Staff Report

Dillon Medical Building

PUD Development Plan

**Prepared by the
Town of Dillon for the
Town Council**

Figure 3. Dillon Medical Building Site Plan

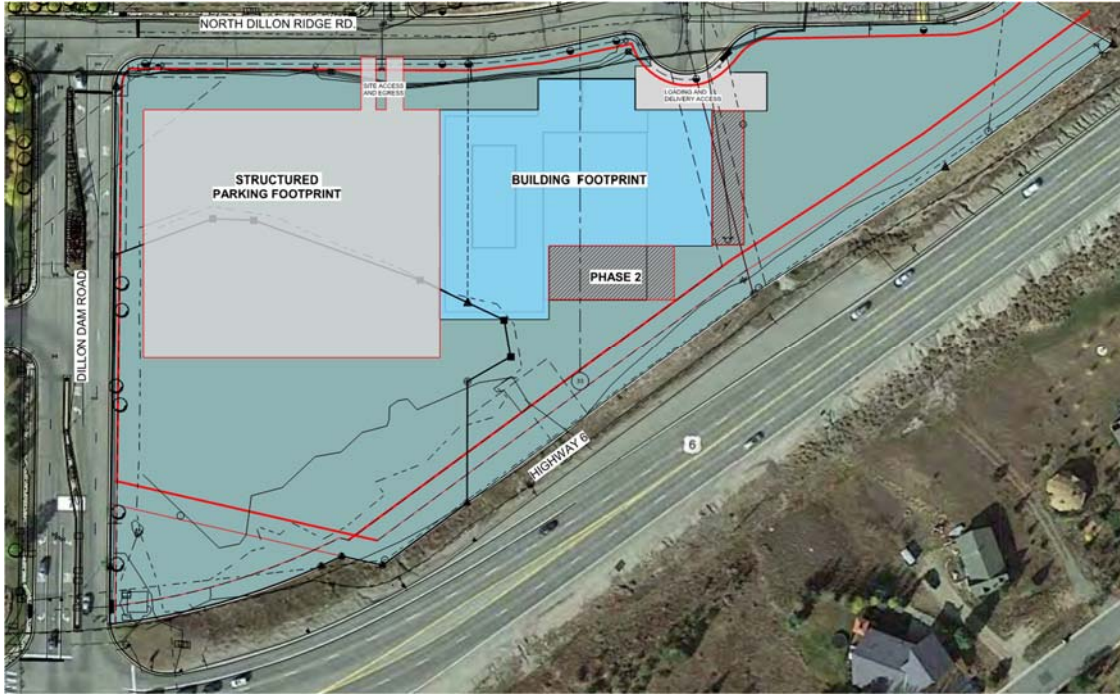
The proposed building will be sited on the northern side of the site adjacent to Dillon Ridge Road (see Figure 3). The parking structure will be constructed on the west side of the building. An enclosed loading dock is proposed for the project on the northeastern corner of the building. The Applicant proposes an enclosed loading area as a special consideration for the residents in the Lookout Ridge Townhomes and the Dillon Ridge Apartments.

Figure 4. Dillon Medical Building Site Plan

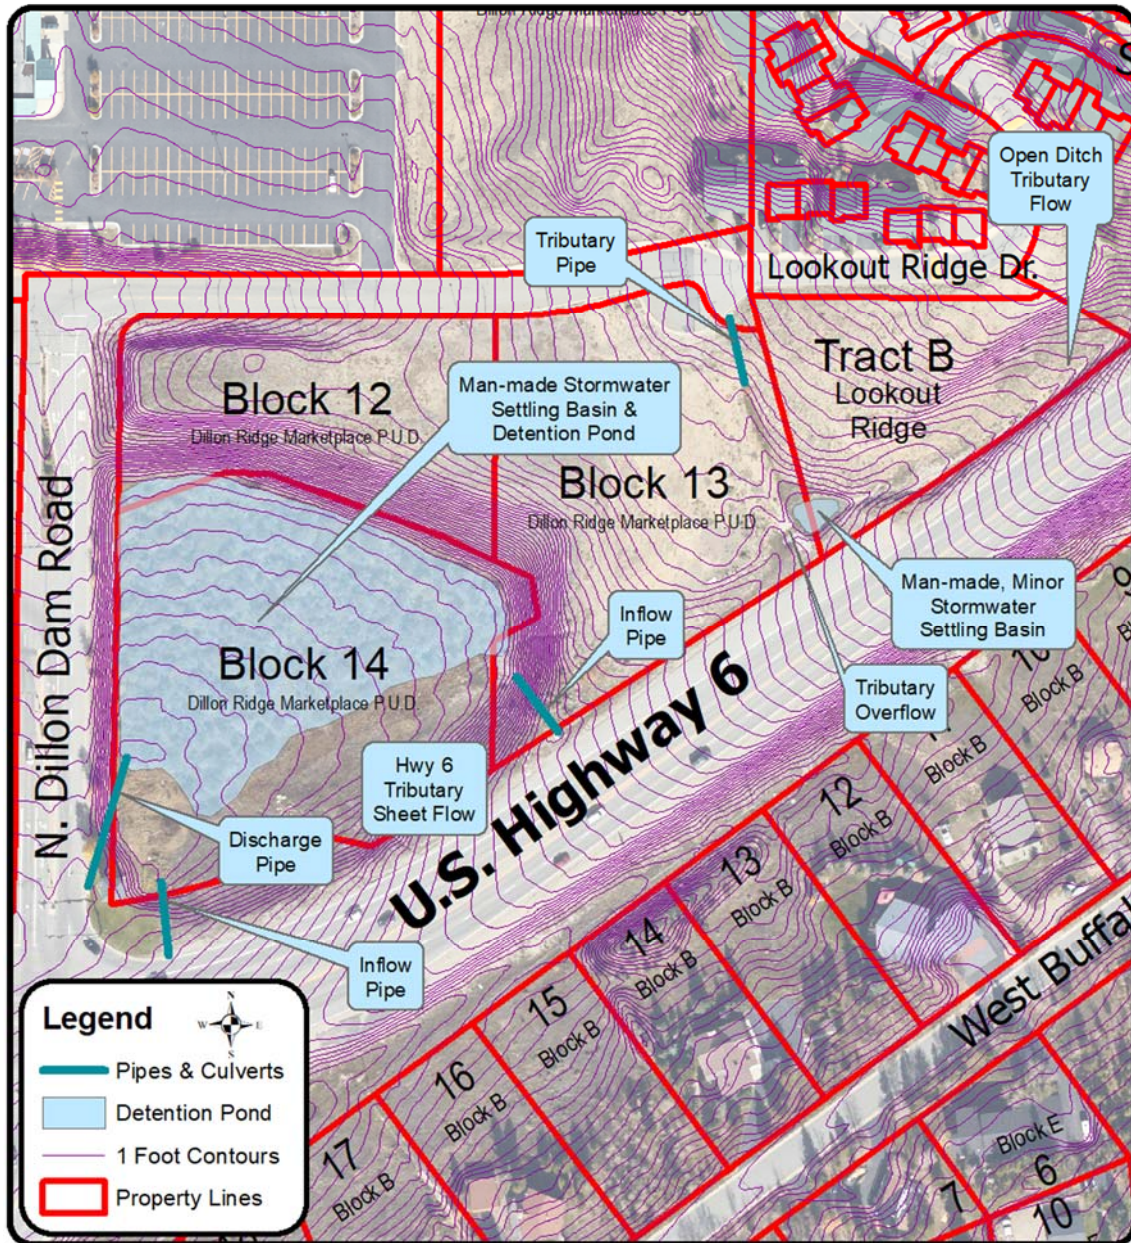
The existing regional, man-made stormwater detention and settling area in the southwestern portion of the site will be reconfigured to accommodate a portion of the building and parking structure and then landscaped with much of the existing on-site vegetation being preserved or replaced, while maintaining sufficient volume for stormwater detention. The detention and settling pond receives stormwater runoff from U.S. Highway 6, portions of Dillon Ridge Marketplace, and portions of Lookout Ridge Townhomes (see Figure 4).

The Applicant has submitted a variance request as a component of this PUD Application to provide for the reconfiguration of the stormwater detention pond. The Applicant has obtained an Approved Jurisdictional Determination from the U.S. Army Corps of Engineers stating that the area is non-jurisdictional and therefore requires no permits or mitigation through that agency. The Corps further states that the subject area is a man-made stormwater runoff receiving and storage area and receives no other consistence inflows of water. By this determination, the Applicant's request for a variance is supported in that the Dillon Municipal Code specifically states, "Wetland does not include man-made ponds

Figure 6: Sunken area: 52,394 sf of 92,875 sf = 56.4%

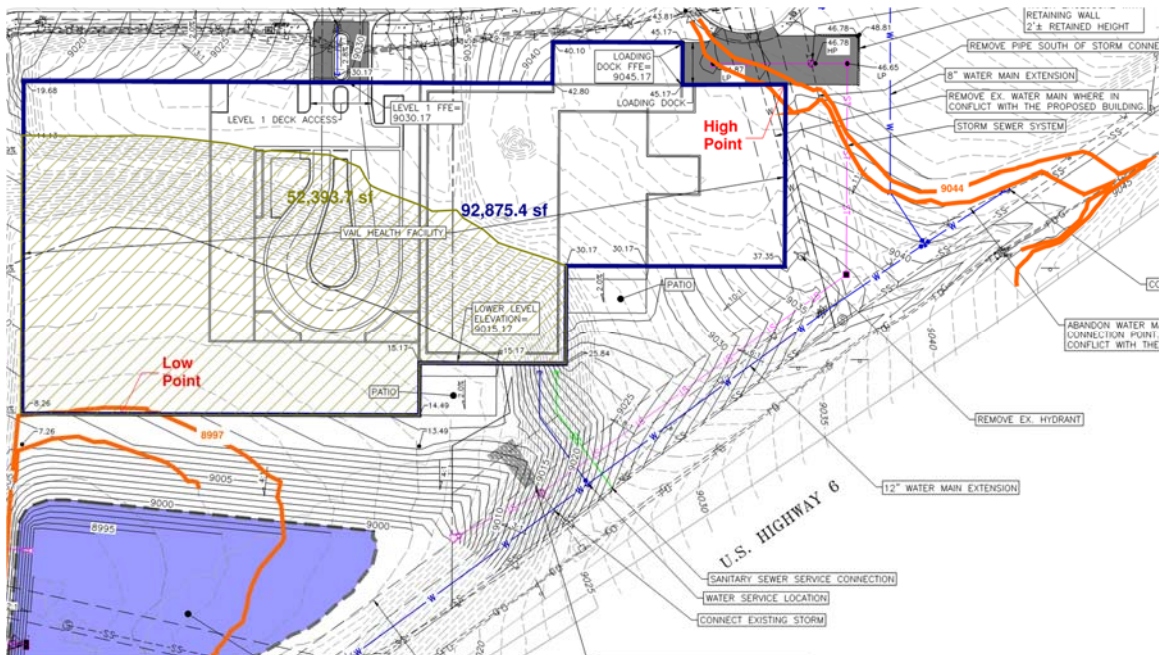
The Code provides for the ability to discount sunken areas within a building footprint if they do not exceed 50% of the total building footprint. In this case, the sunken area is greater than 50%, so that exception may not be directly applied to this particular Application (see Figure 6). Were that exception applicable to the Application, the building height is estimated to be on the order of 36'.

Figure 7: Minor exception to the required yard

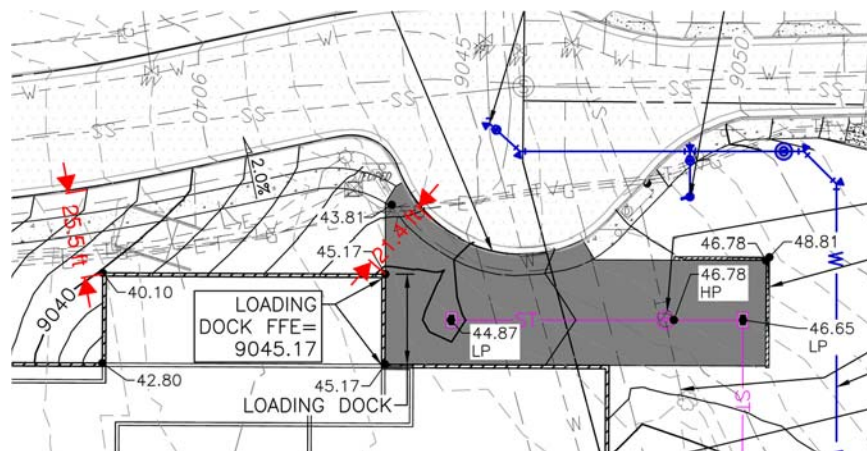
All of the yard requirements are satisfied with the proposed project with one minor exception on the northeastern corner of the building at the enclosed loading dock area, where the front yard setback is 21.4’ from the Dillon Ridge Road Right of way within the existing cul-de-sac (see Figure 7).

Were the courtesy of the enclosed loading area not provided as a consideration for the community, this slightly reduced front yard likely would not exist. Also, were site access available off of US Highway 6, the subject yard would then be considered the rear yard. Yard setbacks may be varied through the PUD process, and the proposed setback is acceptable to the Town.

Figure 8: Lot Coverage: 92,875 sf / 257,299 sf = 36.1%

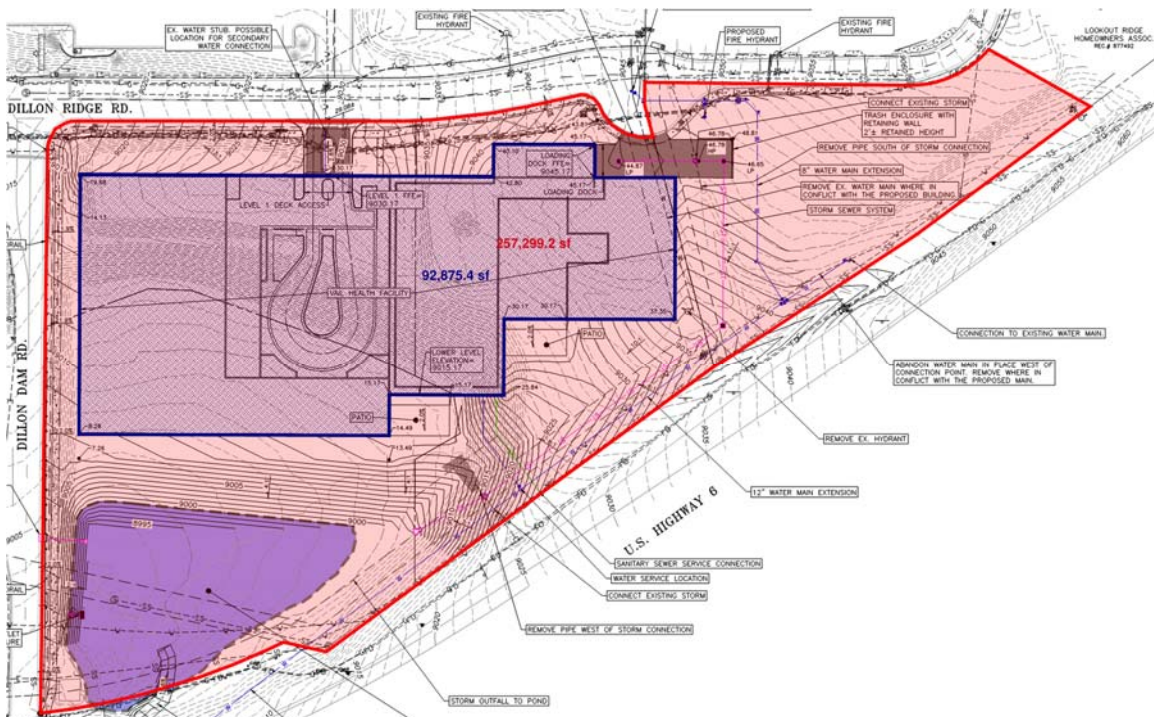
The proposed medical building and attached parking structure have a footprint of 92,875 SF, and the lot area is approximately 257,299 SF. The proposed building covers 36.1% of the lot (see Figure 8). The Applicant requests that they be allowed a total potential percentage of lot coverage to be up to 45% to allow for potential building footprint adjustments during final design. Final design of the building may increase the building size by 5%. The total allowable lot coverage within a Mixed Use (MU) district is 40%; however, the percent lot coverage may be varied through the PUD process.
